Approved Outline Plan Conditions of Approval

These conditions relate to Recommendation 1 for the Outline Plan where Calgary Planning Commission is the Approving Authority. Attachment for Council's reference only.

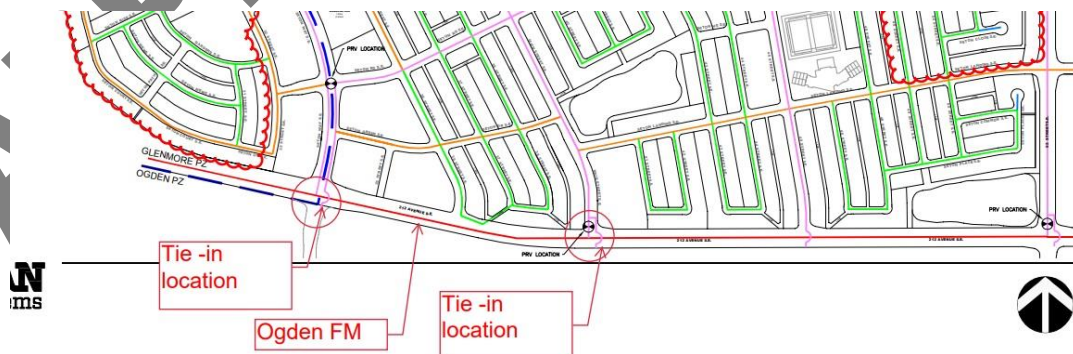
A minimum of two feeds are required from the north to service this site, one from the Ogden feedermain and one from the distribution network. See below sketch for preferred tie-in locations:
